Technical Review

To:	Danielle Ter Huurne	Date:	2/04/2024
Authority:	Otago Regional Council	Ref:	23009.6D_2.0
Consent:	RM23.819 - Hawkeswood Mining Limited		
From	Role in Audit		
Alexandra Badenhop	Hydrogeology, Water Quality

1 Project Summary

Figure 1: Drawdown Assessment provided in Environmental Associates (2023)

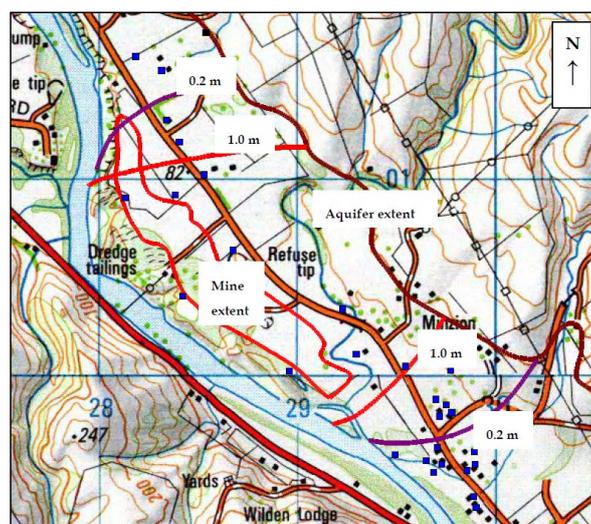
Drawdown at the site will be very complex due to the variable rate pumping, recharge boundaries and small aquifer extents and whilst the groundwater AEE has attempted to be conservative, there is considerable uncertainty in the actual effects that will occur. For this reason, it is considered that there may be effects on both the Tima Burn and other groundwater users, therefore monitoring the effects and using adaptive management strategies is appropriate mitigation for the potential effects. The mapped drawdown assessment provided is replicated in Figure 1. This was based on the original mine extent provided under RM23.474. The two extents are compared in Figure 2.

Given that the mine pit pond has not increased in area or depth, the main difference is in the lateral extent of the mining activities; most significantly the mining extends further to the north and west. The increased extent of the mine and the narrowing of the aquifer to the north-west may result in additional groundwater users being affected by the mining in this area.

It is noted that from correspondence with Environmental Associates (5/03/2024 to Danielle Ter Huurne) that it is considered that mining further to the south will cause greater drawdown in the north than mining in the north itself due to the lesser pumping required in that area. Due to the uncertainty however, it was agreed that the identification of potentially affected wells may now include G43/0184 and G43/0185. It has also been clarified that proposed condition 7 of the proposed groundwater take requires the consent holder to remedy any affected well water supply that will or has become no longer viable due to drawdown from the mine dewatering, irrespective of the list of wells that have been assessed as being potentially affected by the mine dewatering activity. For this reason, it is necessary that monitoring external to the mine site is used to identify drawdown over time and pre-empt any water supply issues.
